## FIELD SERVICE CAMPAIGN – 16125

18 October 2016

Wiring Repair for vehicles built with new VCM (0508095) and Remote Start / Stop W / Emergency Pump feature (0060ABD)

DuraStar®, WorkStar®

**Figure 3. Emergency Pump Circuit**

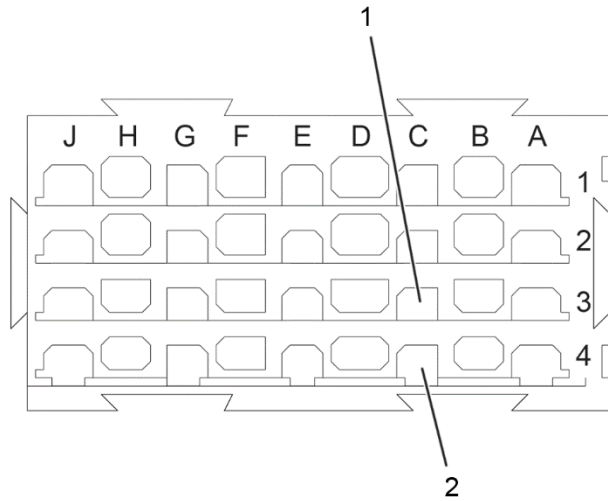
Certain DuraStar® and WorkStar® models may have been built without the necessary ground circuit for the emergency pump relay resulting in the pump to run at all times when the ignition is in the run position.

1. Fuse Block 9, Cavity A4
  2. Fuse Block 9, Cavity B4
7. In Fuse Block 9, remove wire A59CA from Cavity B4 (Figure 3, Item 2) and insert terminal into Cavity A4 (Figure 3, Item 1).

**Figure 4. Fuse Block 9**

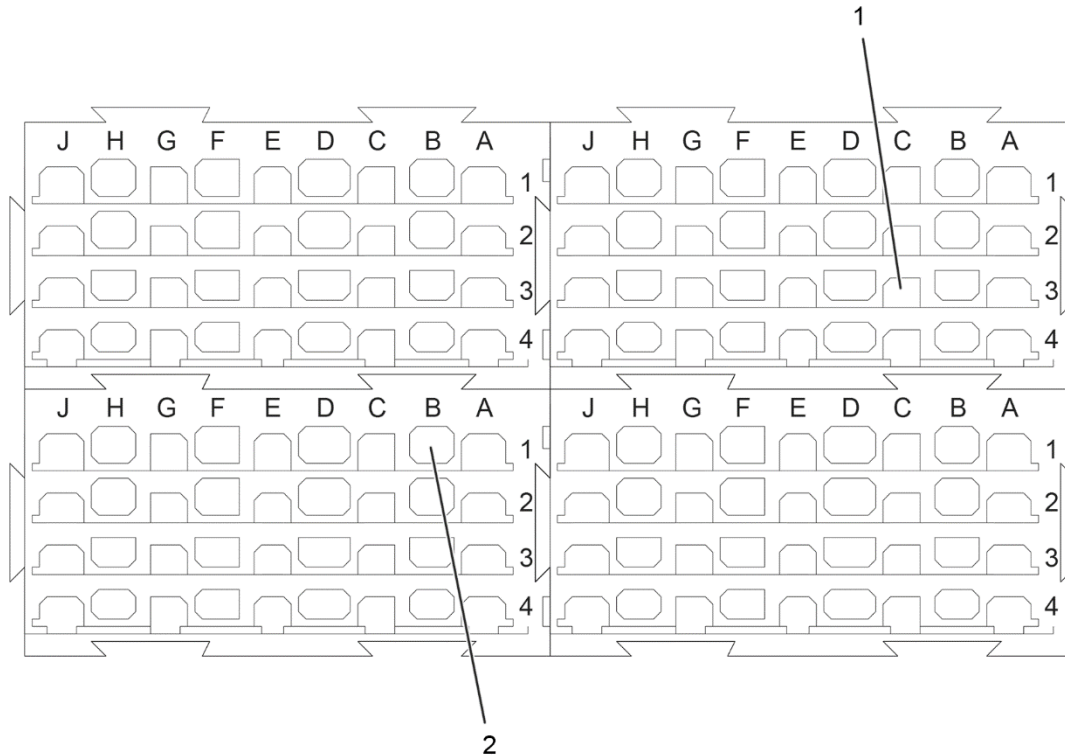
1. Fuse Block 9, Cavity C3
  2. Fuse Block 9, Cavity C4
8. In Fuse Block 9, remove wires A104C/D and A13C from Cavity C3 (Figure 4, Item 1) and Cavity C4 (Figure 4, Item 2).
  9. Cut wire A104C/D at wire end of double crimped terminal. Cut as close to terminal as possible, taking care not to damage insulation on other wire.
  10. Reinsert terminal with wire removed into Cavity C4 (Figure 4, Item 2).

**Figure 5. Cavity Jumper Wire**

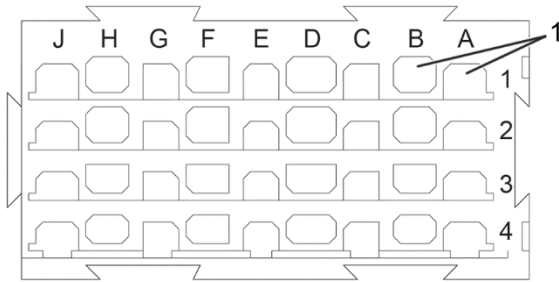
11. Create a Jumper Wire (A104V), consisting of 440 mm of 19 ga. gray TXL wire with a 3534164C1 terminal on both ends.

12. Connect one terminal of jumper wire to Cavity B1 on Fuse Block 8 (Figure 5, Item 2). Connect other terminal to Cavity C3 on Fuse Block 9 (Figure 5, Item 1).
